21 September 2020  
Our Ref: 5285N.4PS

**Re: 634/2020/E-PP Proposed Rezoning of RE2 Private Recreation Land to R3 Medium Density Residential – The Meadows, Bardia**

DFP Planning has been commissioned on behalf of Jessica Investments Pty Ltd to respond to the Campbelltown Local Planning Panel's recommendations dated 22 July 2020 in respect of the Planning Proposal referred to above.

Figure 1 Concept Plan for Pocket Park

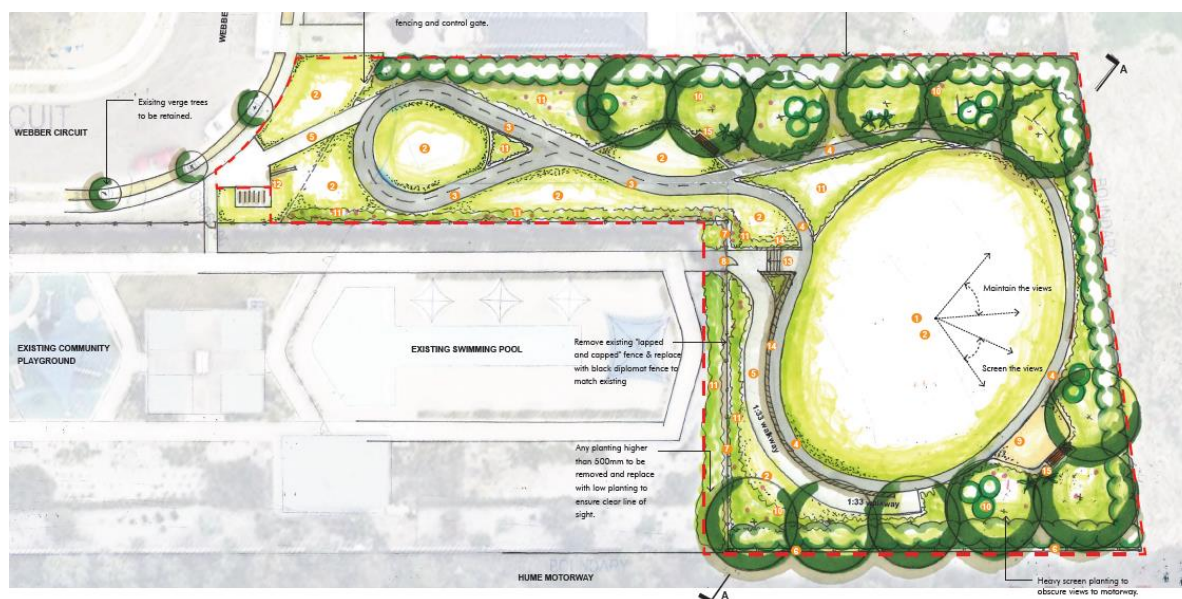
- b) *Lot 40 to the north of the established community facility should remain zoned RE2 and be incorporated as a pocket park or similar and/or incorporated into the community facility / community scheme as a public benefit for the existing and additional residents. The embellishment of this space should also be linked to any approved proposal.*

- Rezoning of Lot 39 DP 280076 from RE2 Private Recreation to R3 Medium Density Residential to provide for approximately 22 residential lots.
- Lot 40 DP 280076 to retain the RE2 Private Recreation zoning and to be developed into a pocket park (**Figure 1**). A masterplan has been provided at **Attachment 1**.
- Lot 40 to be added to the Community Title lot (Lot 1 DP270983) for the estate to provide amenity benefits for all residents of The Meadows.

A masterplan for the pocket park on Lot 40 has been prepared at **Attachment 1**. As indicated in **Figure 1** above, the park includes the following mix of passive and active recreation facilities:

- Multi-purpose open gather/ kick-about space;
- Open turf area;
- A mixture of one-way (1 metre wide) and two-way (2 metres wide) bike tracks;
- Concrete footpaths (with a maximum fall of 1:33);
- Acoustic wall – 3.5 metres in height;
- 1.8 metre tubular steel fence (Diplomat, to match existing pool fence);
- Automatic self-closing swing gate to pool enclosure;
- Open gravel area;
- Dense landscape planting buffer to provide privacy screening adjacent to acoustic fence;
- Low planting to ensure passive surveillance and open views;
- Concrete stairs to provide accessibility between pool and multipurpose gathering space;
- Low retaining & seating wall; and
- Bench seats.
